# UNITED STATES PATENT AND TRADEMARK OFFICE

10/572,679

<b>Office Action Summary</b>	<b>Application No.</b> 10/572,679	<b>Applicant(s)</b> ONO ET AL.	
	<b>Examiner</b> CLIFFORD J. LOUDEN	<b>Art Unit</b> 3679

## DETAILED ACTION

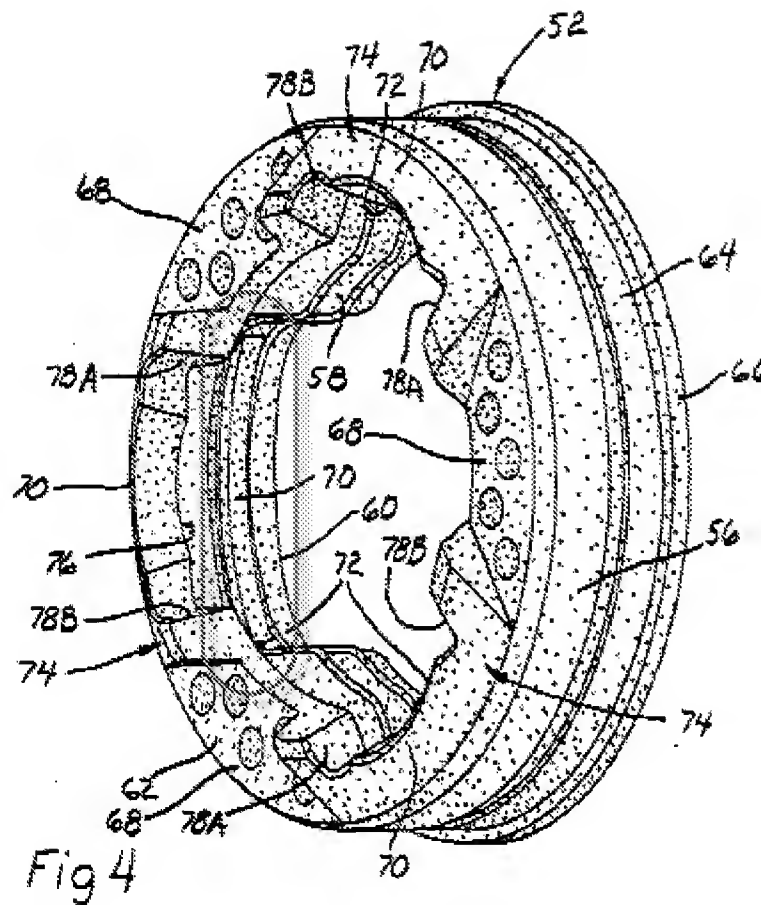
7. Claim 1 is rejected under 35 U.S.C. 103(a) as being unpatentable over Schulz et al., US 5,529,538. Schulz et al. show a universal joint boot comprising: a cylindrical bellows part (42) that has valley and peaks formed continuously in a repetitive manner (shown in Fig. 1) and can extend and contract (shown in Fig. 2); a ring-shaped mounting part (52) that is formed at one end of the bellows part and into which a case (12) for receiving one member of two members moving relatively to each other is inserted (shown in Fig. 1); and a seal lip (70) that is formed toward a peripheral direction of an inner peripheral surface of the mounting part to which the case is mounted (shown in Fig. 4), wherein the inner peripheral surface has protrusions (68) protruding toward an axial center of the ring-shaped mounting part, and wherein a height of the seal lip becomes lower from a bottom of the protrusion to a peak (shown encircled in the diagram below).

Schulz et al. do not expressly disclose wherein a width of the seal lip becomes wider from the bottom of the protrusion to the peak. However, at the time of the invention, it would have been obvious to one of ordinary skill in the art to modify the seal lip to provide an increase of surface area for the purpose of improving the frictional seal between the bushing and the tulip housing.
